BUILDING NO. J-10

PORTAGE ORDNANCE DEPOT
BOILER HOUSE & TOILETS FOR
BUNDLE AMMUNITION PACKING BLDGS.
FOUNDATION & FLOOR PLANS—ELEVATIONS.

REVISION NO. 4 APPROVED BY:
DRAWING REVISED PER FIELD SURVEY
DATE NOVEMBER 15TH 1956
CONTRACT NO. DA-11-173-ORD-65
TRYGVE HOFF & ASSOCIATES
REV. BY K.C. CHK'D BY E.N.M.
See Gen. Plan 6988-326 A
L. H. EATON · PLANT ENGINEER
C. H. WILLISTON · ASST. GEN'L. MGR.
C. W. MELDRUM · LT. COL. ORD. DEPT. COMMANDING

FLOOR PLAN
SCALE 1/4" = 1'-0"

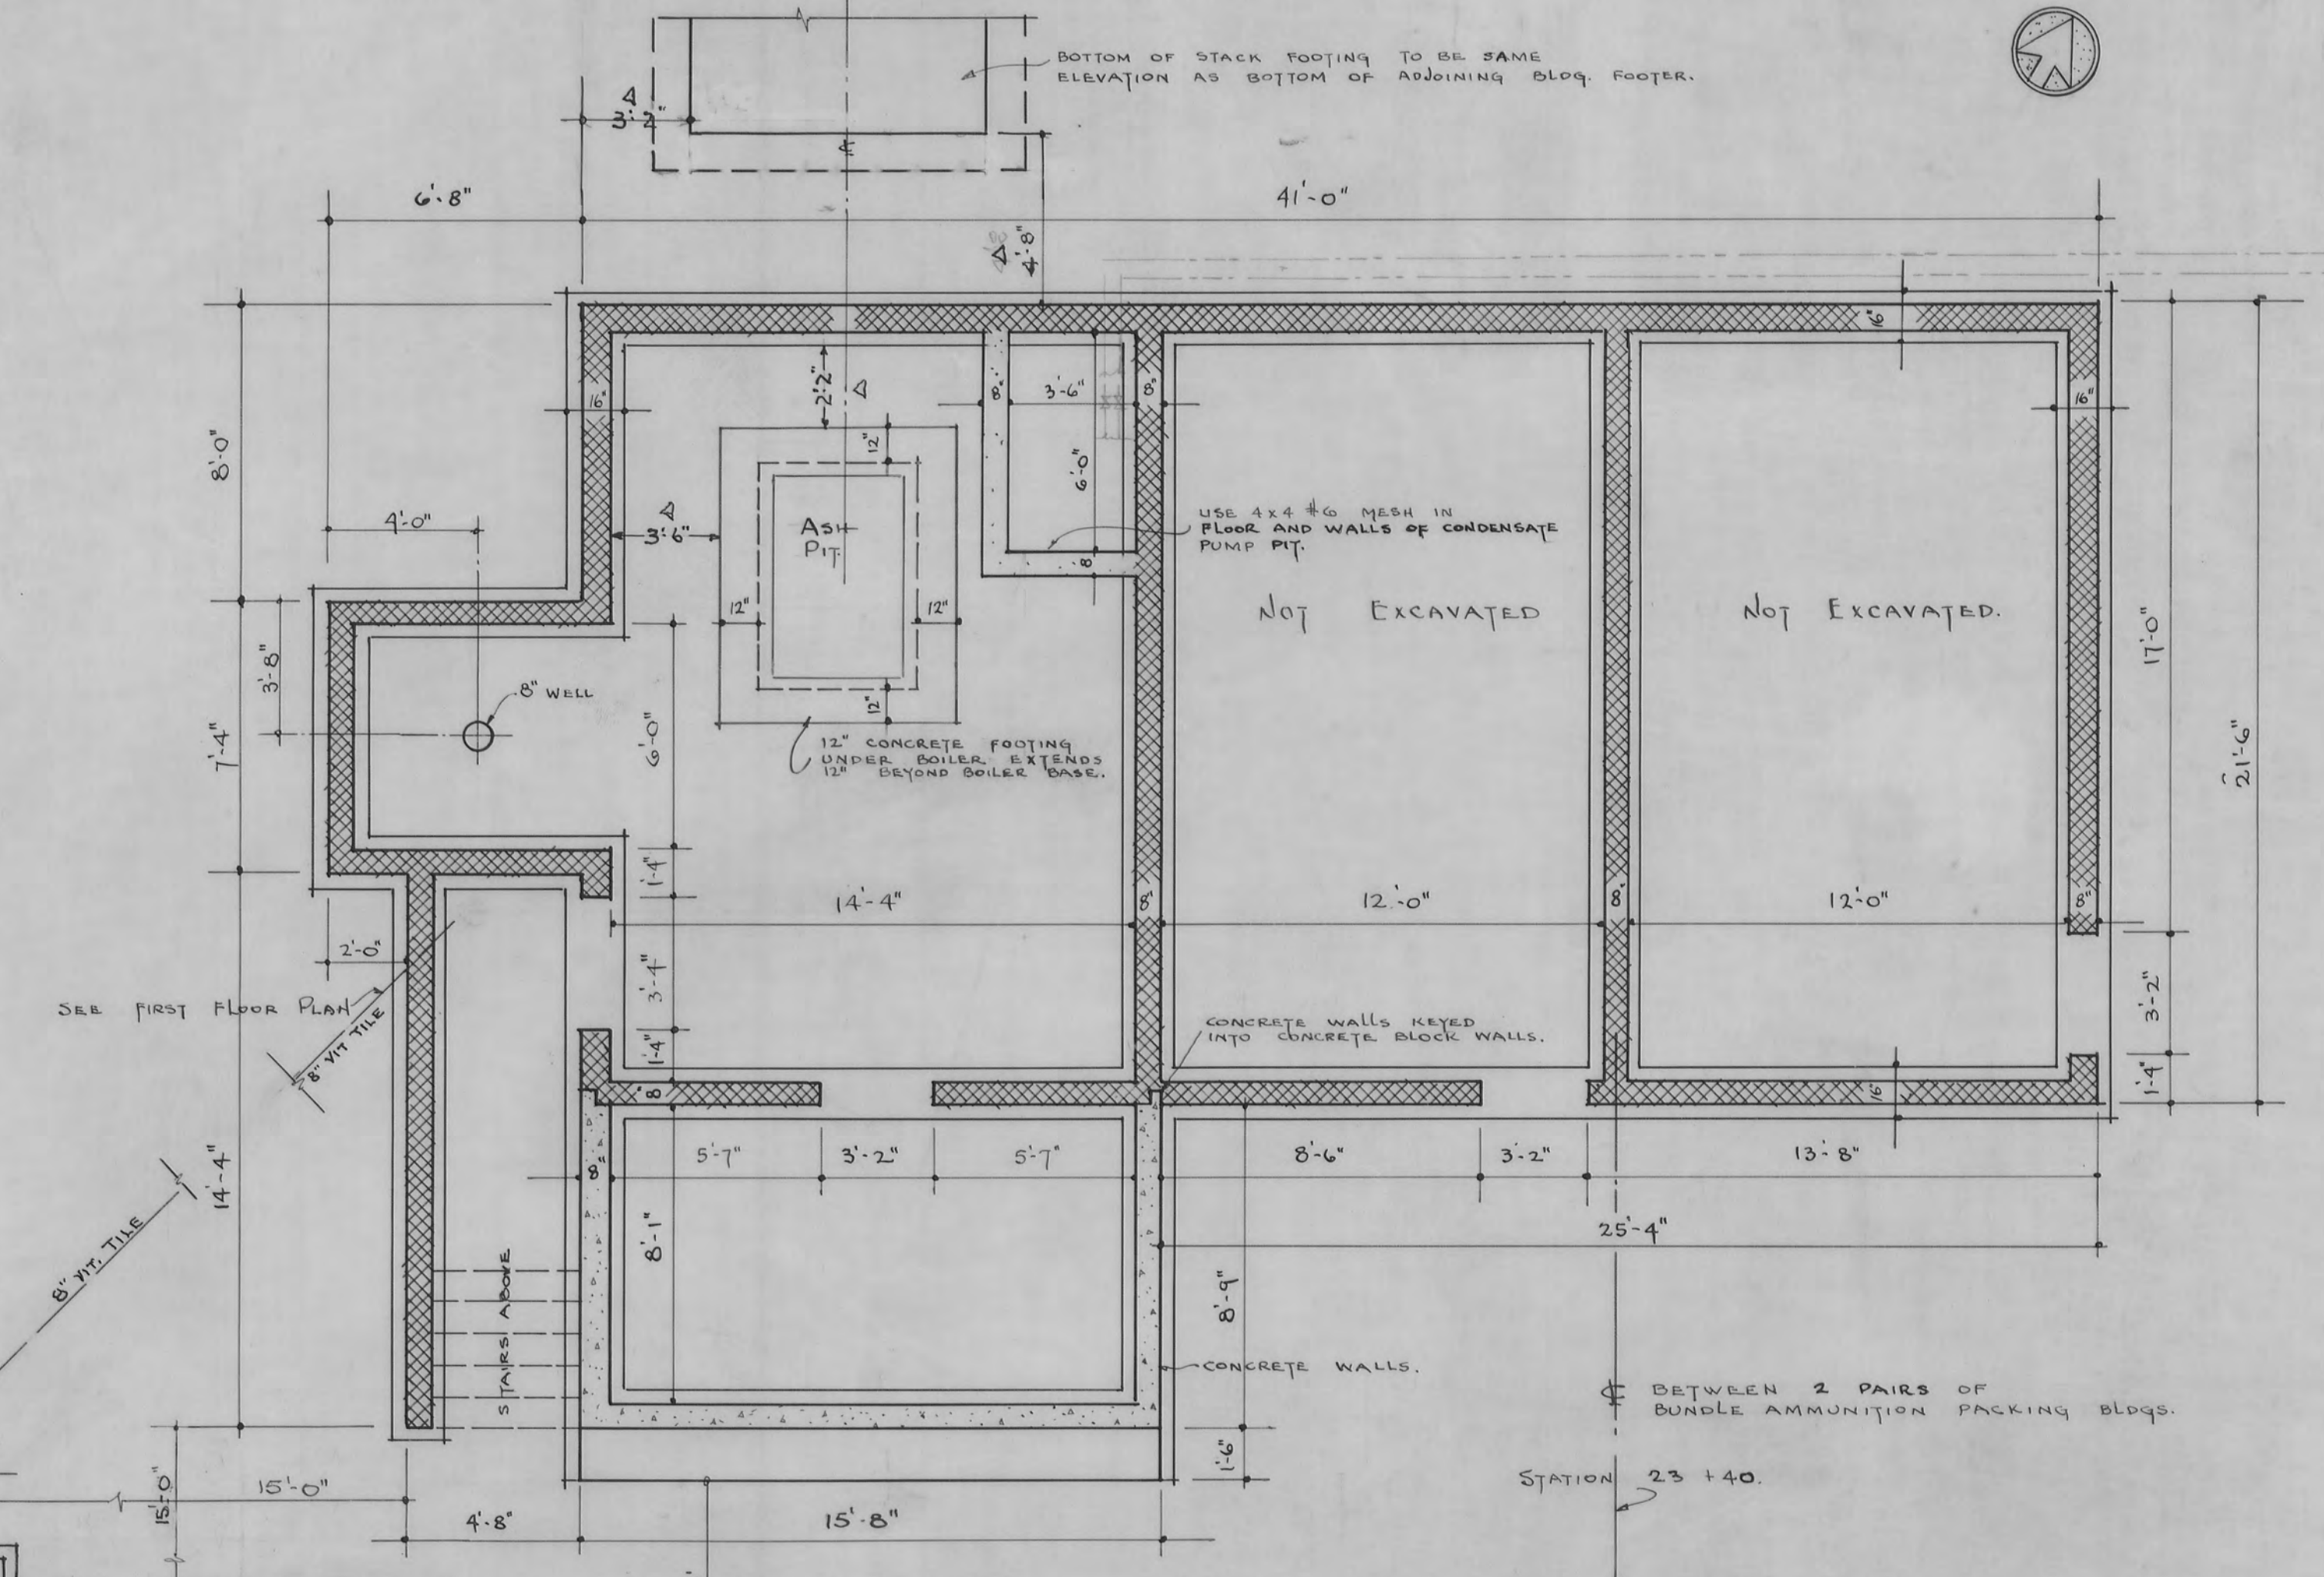
△ CABINET & DRINKING FOUNTAIN IN TOILET ROOM MOVED—URINAL TROUGH CHANGED TO THREE INDIVIDUAL URINALS.
